PLAN COMMISSION

INTER-DEPARTMENTAL REVIEW COMMITTEE REPORT

SAM'S CLUB – 611 E. BUTTERFIELD ROAD

PC 15-21

1. *Building Height*

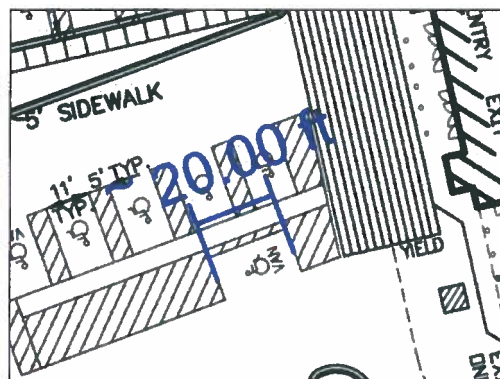
Pursuant to Section 155.415 (G) of the Lombard Zoning Ordinance, the petitioner requests a deviation to increase the maximum permitted building height from thirty-feet (30') to thirty-five feet and four inches (35'4"). Staff can support the requested deviation as the majority of the height of the structure beyond thirty feet (30') appears to be a parapet wall, which is not

traditionally included in the overall measured height of a structure. However, the relief request was published for the most extreme situation due to ongoing engineering analysis that may result in changes in final grading from which the building height is measured. In this scenario, staff supports the requested deviation and finds that the proposed deviation would not adversely impact the value or use of any other property, especially in consideration that the building heights of the surrounding structures exceed the proposed height of the Sam's Club.

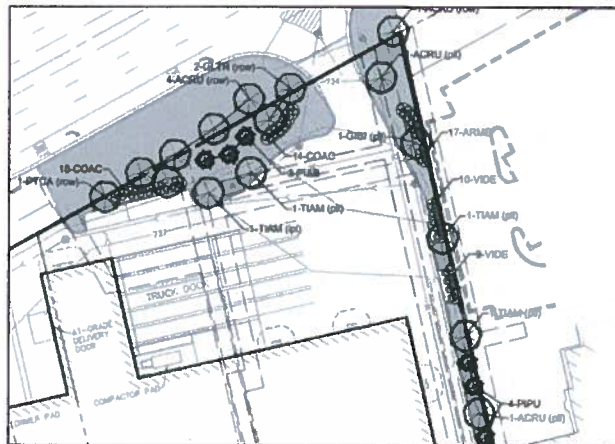
- d. Pursuant to Section 155.602 (A)(10)(d)(iv) of the Lombard Zoning Ordinance, the petitioner requests a deviation to increase the maximum height for light poles from forty feet (40') to forty-two feet (42'). Similar to subitem "c" above, in their response to standards the petitioner states that the increased light pole height allows for a reduction in the number of light poles required, which if not granted would require a further reduction in the number of parking spaces provided.

Staff can support the requested deviation to increase the maximum light pole height based on the reasons outlined by the petitioner, but also because there is a precedent for forty-five foot (45') tall light poles within the Yorktown Shopping Center. Forty-five foot (45') tall light poles are permitted within shared pedestrian access shopping centers, but not within single-tenant properties. The forty-five foot (45') tall light poles at Yorktown Shopping Center have been in place without adversely impacting the value or use of any other properties.

1. Setback & Bulk Requirements

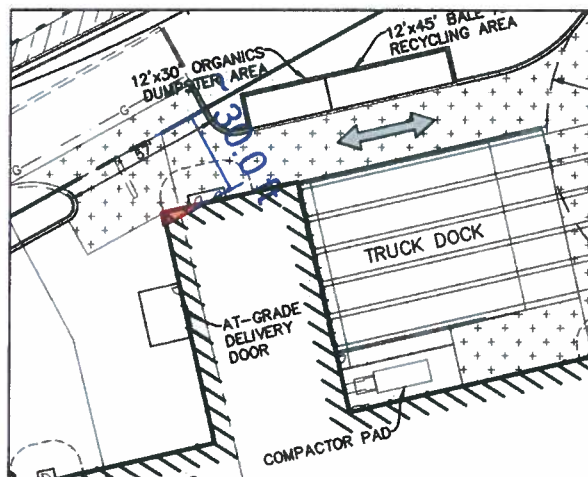
- a. Pursuant to Section 155.508 (C)(6)(a) of the Lombard Zoning Ordinance, the petitioner requests a variation to deviate from Section 155.415 (F)(2) to reduce the minimum corner side yard setback from thirty feet (30') to twenty-five feet (25'). In their response to standards, the petitioner states that this request is based on the unique topography of the lot in which there is a significant grade differential at the southeastern corner of the property.

- b. Pursuant to Section 155.210 (D)(1) of the Lombard Zoning Ordinance, the petitioner requests a variation to allow for garbage dumpsters and recycling bins to be located within a corner side yard setback. In their response to standards, the petitioner states that the proposed location for the garbage dumpsters and recycling bins is based on their desire to keep them furthest away from the adjacent Embassy Suites Hotel while still being practical for the petitioner's needs.

Staff can support the requested variation based on the combination of the reason outlined by the petitioner and that based on the unique layout of the site, there is no reasonable alternative location that would not also require some degree of zoning relief. The petitioner has provided extensive screening and has made a request for additional zoning relief to provide for a screening wall higher than that currently allowed by Village Code to ensure that the garbage dumpsters and recycling bins will not be visible from public roadways or the ground level of the adjacent property to the east.
